Access Compliance Report Public Rights-of-Way (Curb Ramps)

Main Street: MAYBECK_LN Cross Street: COURTNEY_CIR Location: S

ADA ID: RPRK211025113638 Ramp Type: Type 4 - Parallel Initial Pass/Fail: Fail Overall Compliance: No Severity Score: 15

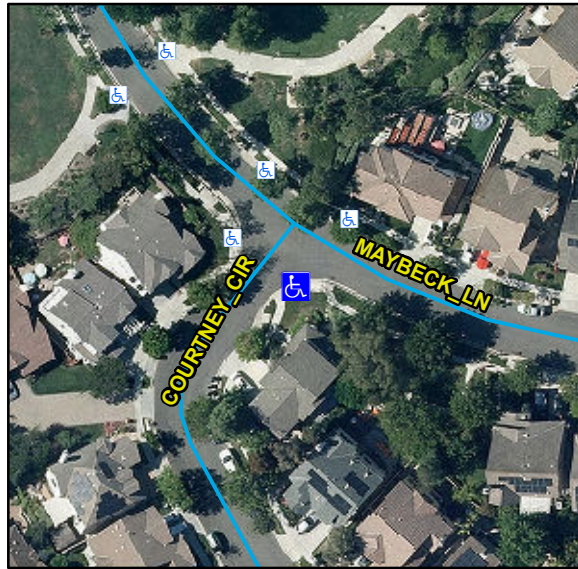
R204.3, R304.3.2, STD 1115

Remove & Replace Curb Ramp With Two New Directional Ramps or Equivalent.
